100 ROY

**DESIGN RECOMMENDATION SUBMITTAL**

Project # 3030925-LU

SECOND EARLY DESIGN GUIDANCE May 22, 2019  
PRIORITIES & BOARD RECOMMENDATIONS

COMPOSITE SITE PLAN LEVEL TWO - LANDSCAPED TERRACE SETBACK NORTH

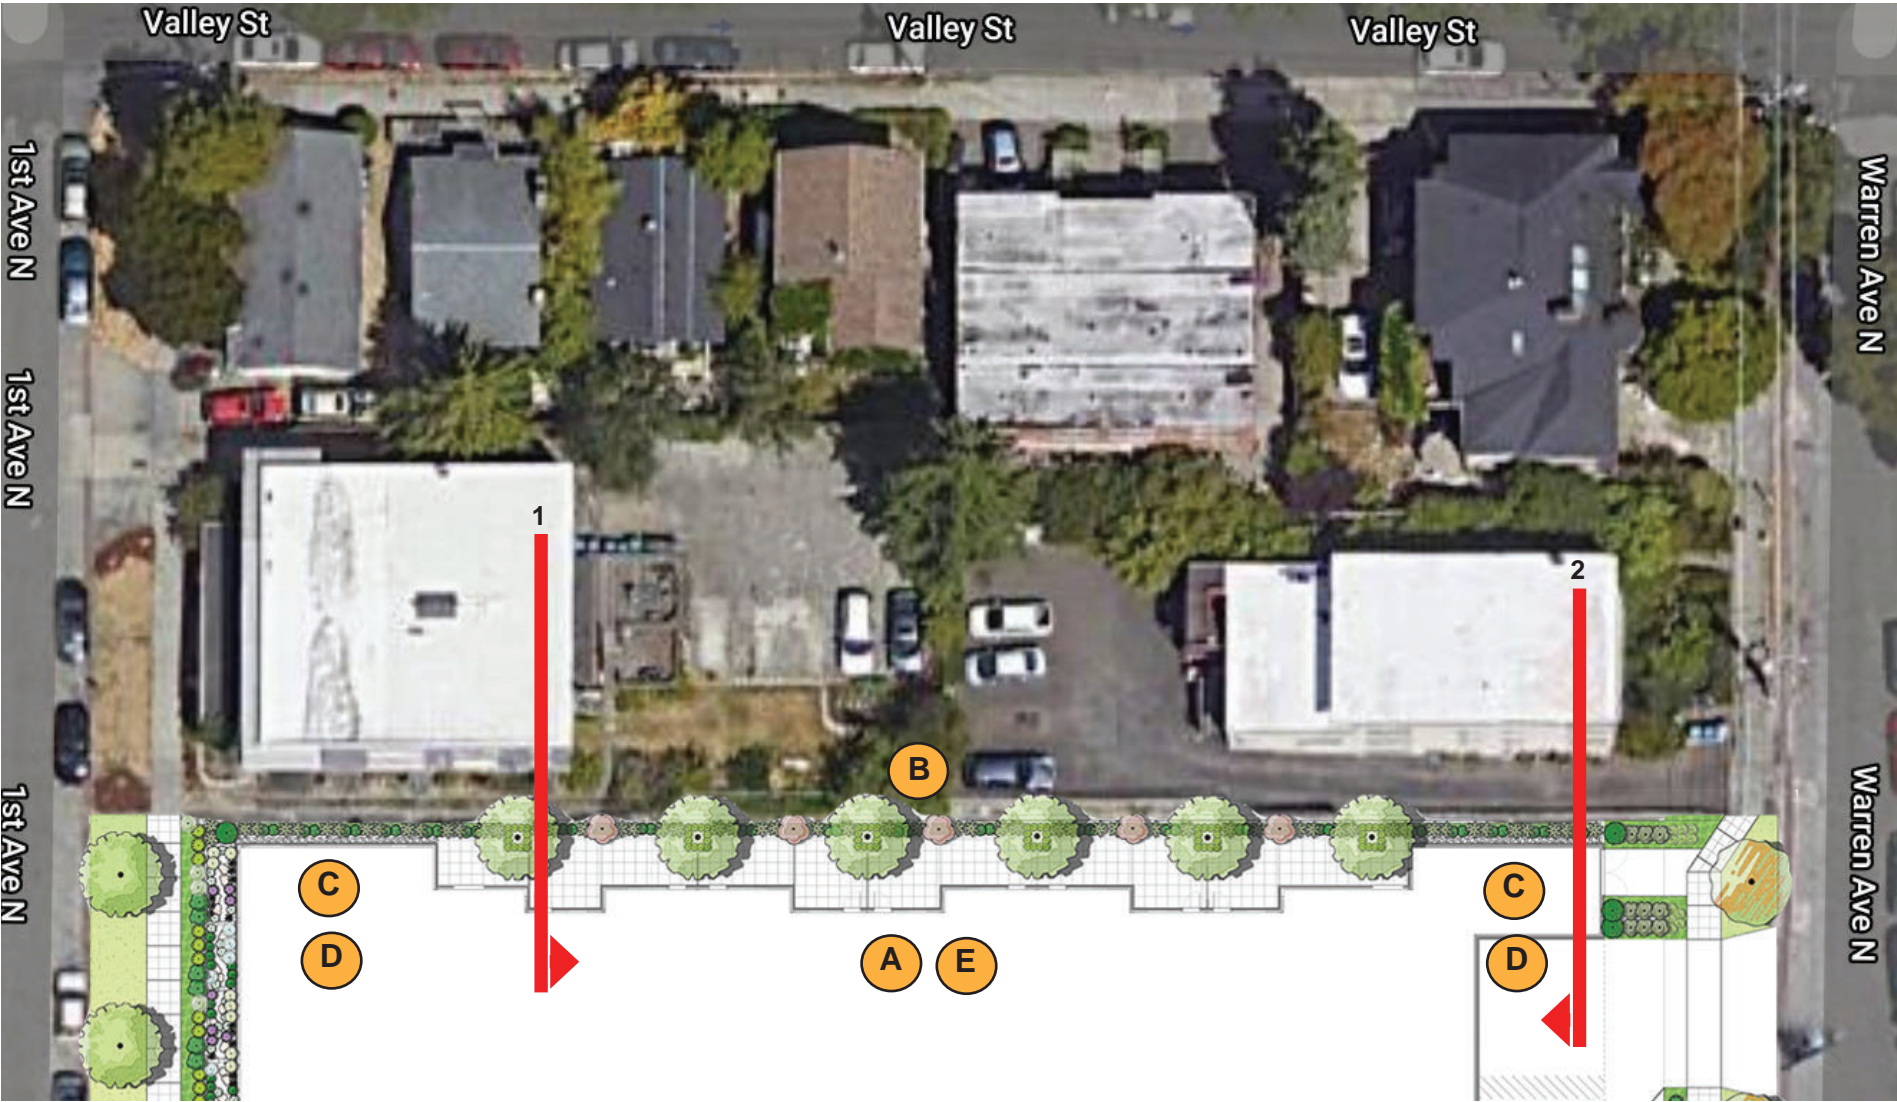
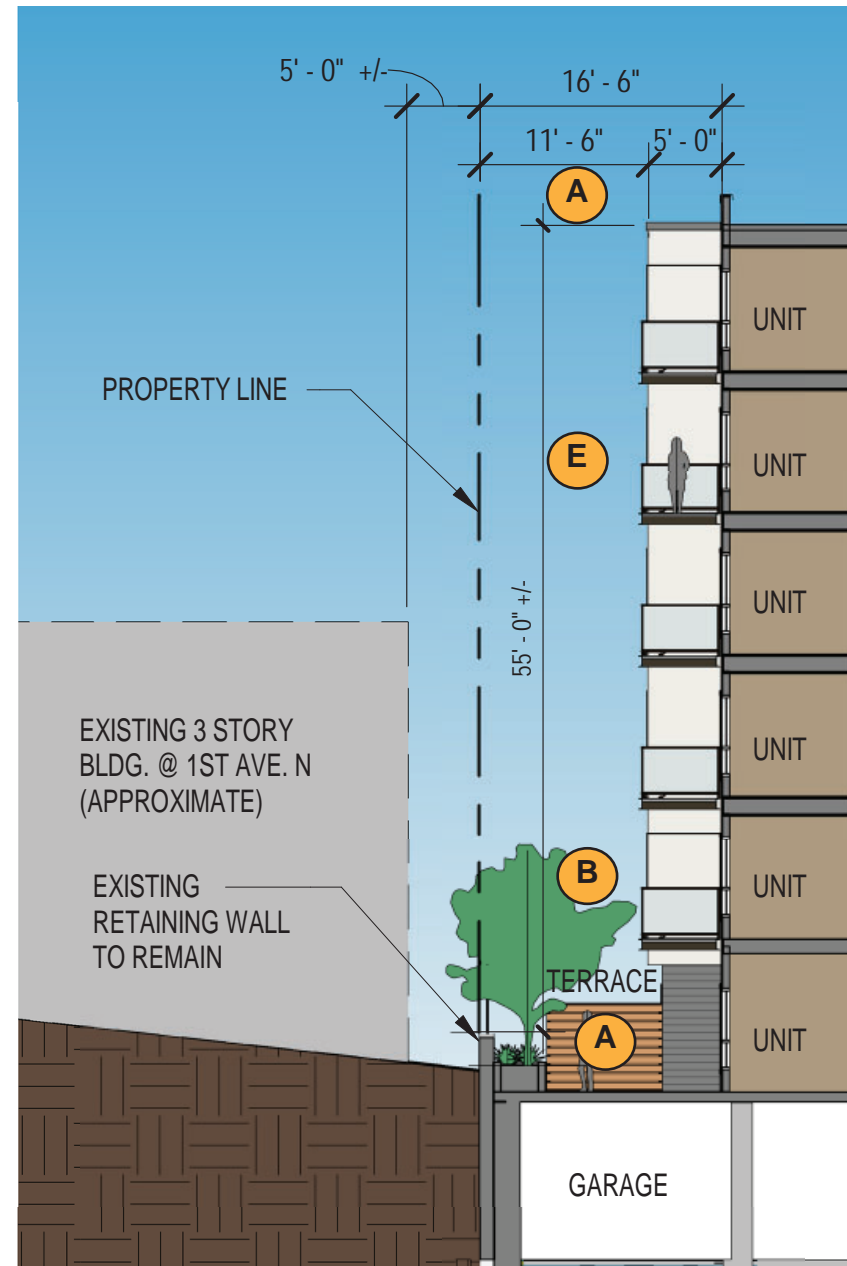
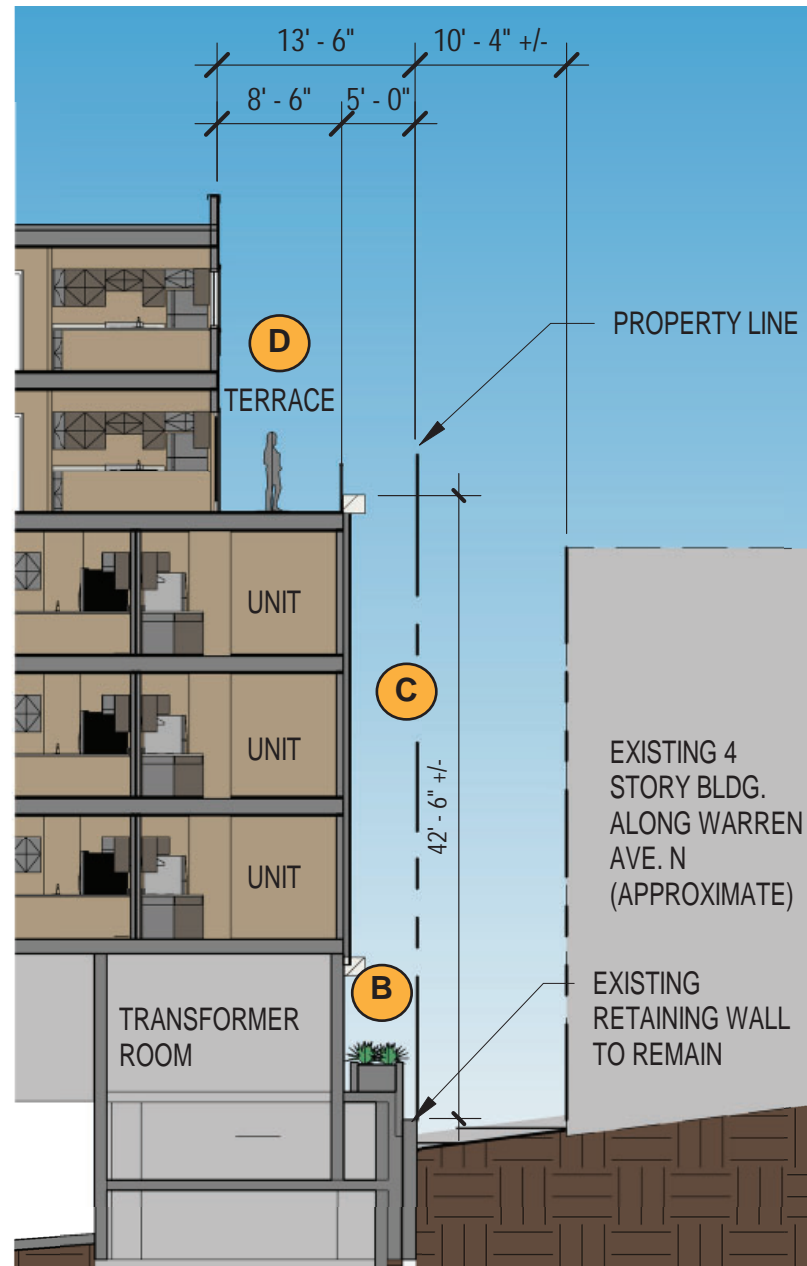
1. Response to past guidance, massing and architectural concept
  - a. The Board was appreciative of the applicant's responses to guidance provided at the first EDG. They stated that the proposals numbered four five and six showed a clear evolution on the massing that indicated the applicant's comprehension of previous guidance. They unanimously agreed that the Applicant's preferred option best responded to previous guidance to create open space and visual interest. (CS2 and DC2)

- A** The majority of the north façade has been setback to create a landscaped residential terrace to reduce the impact on the neighbors.
- B** The transition to the residential terrace is softened with a raised planter at the property line containing a mix of low plantings and trees (see landscape plan sheet 72 and an aluminum picket fence atop the existing retaining wall).

- C** At the corner locations where setback is reduced, the facade has been designed to be sensitive to the adjacent neighbors with limited window overlook for privacy, as wells as quality materials, raised planters and fence buffers.

- E** The overall massing of the east, west and north facades is reduced in scale through increased modulation at the units, the addition of balconies and the use of more residentially scaled materials such as the Woodtone stained lapped siding, wood privacy screens and window trim.

NORTH MASSING AS PRESENTED AT EDG

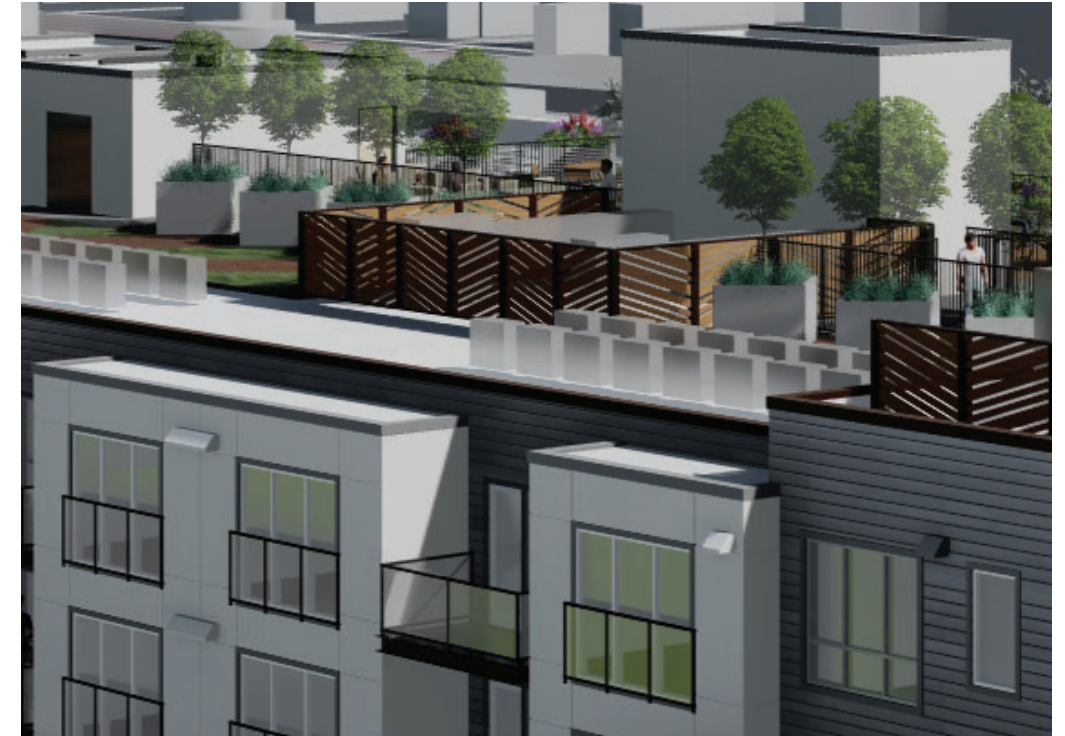
1. Response to past guidance, massing and architectural concept
  - a. The Board was appreciative of the applicant's responses to guidance provided at the first EDG. They stated that the proposals numbered four five and six showed a clear evolution on the massing that indicated the applicant's comprehension of previous guidance. They unanimously agreed that the Applicant's preferred option best responded to previous guidance to create open space and visual interest. (CS2 and DC2)

- E** *The north facade as presented at EDG has been refined to reduce the apparent height, bulk and scale of the massing to be more compatible with the lower scale residential neighbors to the north.*
  - *The previously proposed "frame" elements have been removed at the upper corners and the center bays.*
  - *The roof projections over the balconies have been removed.*
  - *The white bay modulations have been reduced in height allowing the lapped sided facade to be a consistent background element and to reduce the overall apparent height of the building.*

- E** Secondary architectural elements have been added / refined to better transition to the residential character of the east, west and north facades.
- Juliette balconies have been added at north facade white bays
  - Window trim has been added to provide detail and contrast.
  - Tall, linear wood privacy screens have been added to provide detail and warmth.
  - Contrasting coping has been added to lapped siding facade parapet.
  - Contrasting coping has been added to white bay parapet.
  - Level two terrace, landscaped planters soften the edges and fencing provides security.
  - Rooftop terrace provides landscaping, activity and visual interest to uphill neighbors.

- Transition:  
**E** Lowered bay modulation helps to reduce scale and apparent height. Balconies, window trim and siding texture provide residentially scaled secondary architectural elements.

PROPOSED EDG PLAZA

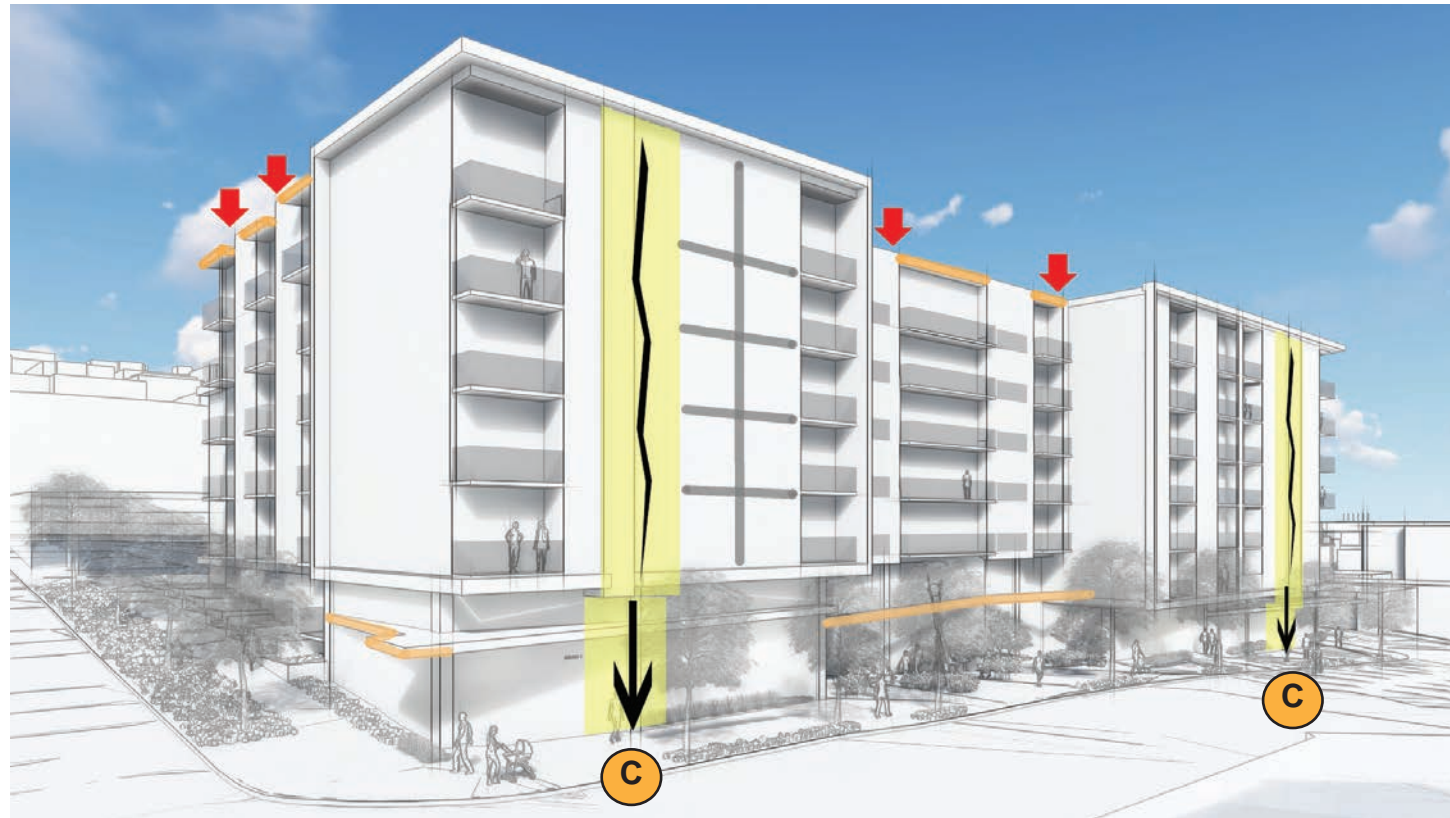
- i. Provide secondary details on the proposal to add visual interest
  - ii. Call upon elements of the ground plane elsewhere in the building's design
    - 1. While the Board suggested the residential entry as a potential organizing element to guide this process, they were keen to give the applicant the flexibility to find design solutions that they felt best meet the intent of this guidance. (CS3, DC2 and CS3 – Uptown, and DC4)

- b. The Board stated that they expect to see secondary details to add visual interest and some level of character that transitions between the façade and the ground plane. The applicant should be prepared to demonstrate how they developed these features in future design review proposals. (CS2 Uptown, DC4 and DC4-Uptown)

- A** The unique faceted facade of the shopfronts creates a dynamic pedestrian experience leading into and activating the large public plaza open space. The faceted ground plane combined with the more simple contemporary urban design of the building above strengthens the overall design concept of “Pedestrian Urbanism” and fits well into the vision and goals of Uptown and the Class 1 Pedestrian Roy Street frontage.

- B** Secondary elements have been incorporated into the design to provide visual interest, to enhance the pedestrian experience and to bring the upper level and ground plane together into a cohesive design. These elements include:

- Public art
- C** Angular elements of the ground plane are integrated into the building above through two unique art focal facade features that connect the upper floors all the way down to the retail frontage, identifying the key corner commercial entry locations. The angular motif is also incorporated into the plaza design and entry pathway. The middle bay is capped with a trellis element visually linking to the streetscape trellis elements.

- D** The storefront windows have been revised from clear aluminum to a dark anodized bronze to look less “office-like”. Operable storefronts are provided at the corner retail spaces at the public plaza providing opportunities for outdoor seating and/or interaction with the activities in the plaza. We have opted to keep the storefront system simple to serve as a backdrop to the hardscape and landscape frontage, paving patterns, upper level trellises, signage and art pieces. Each shopfront has a subtly different patterning and character. This approach will allow the commercial tenants the opportunity to express their own brand character as what is seen beyond the storefronts. See sheets 54-71 for storefront sections and renderings.

ROOF TERRACE

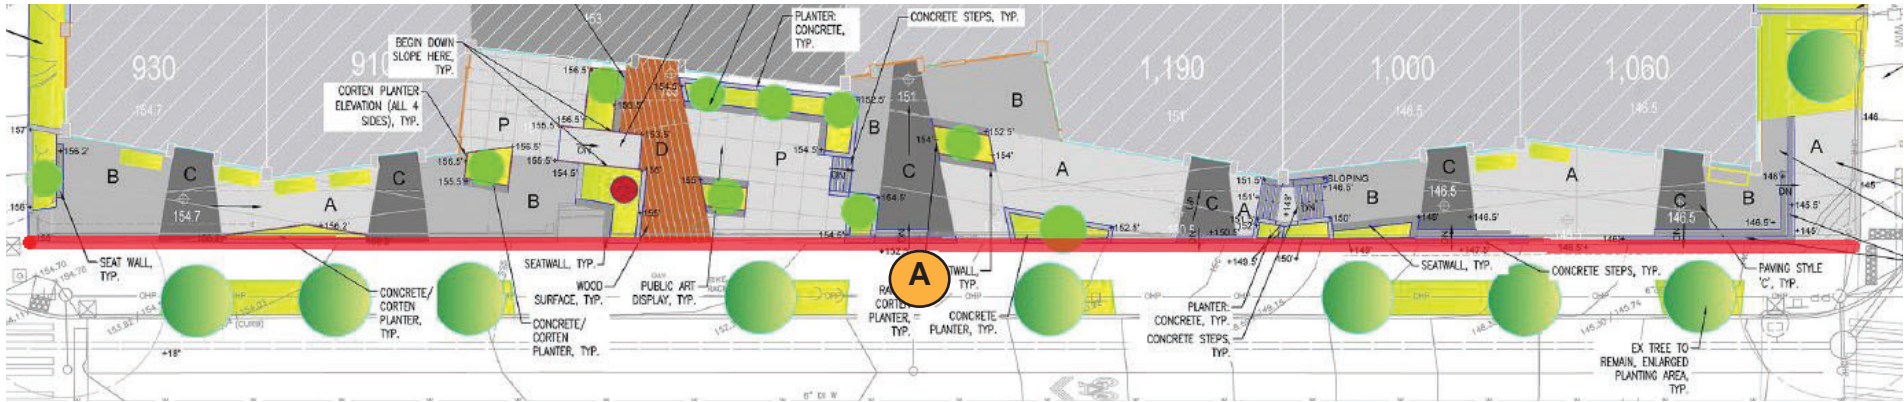
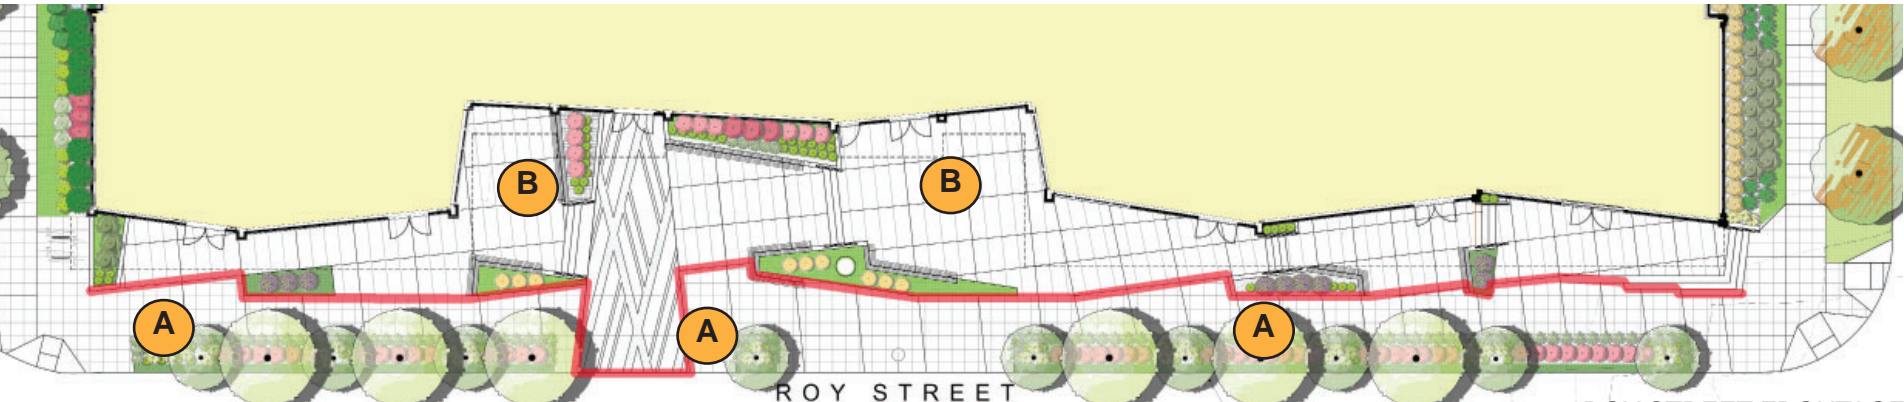
f. The surrounding buildings and topography of the local area will make the roof of this building very visible. For this reason, the Board emphasized the importance of the “fifth” elevation (the roof). They requested perspectives and renderings from the hill to the north, demonstrating a thoughtful, well-integrated design of the roof. (CS1 Uptown, CS3 Uptown, CS1, CS3 DC2 and DC3)

The proposed design includes a roof terrace. Green roof and large plantings are provided along the north side to soften the views from uphill. Activity, furnishings, hardscape and landscape will create visual interest and the “fifth elevation” at the roof. See renderings sheet 53 & landscape sheet 74.
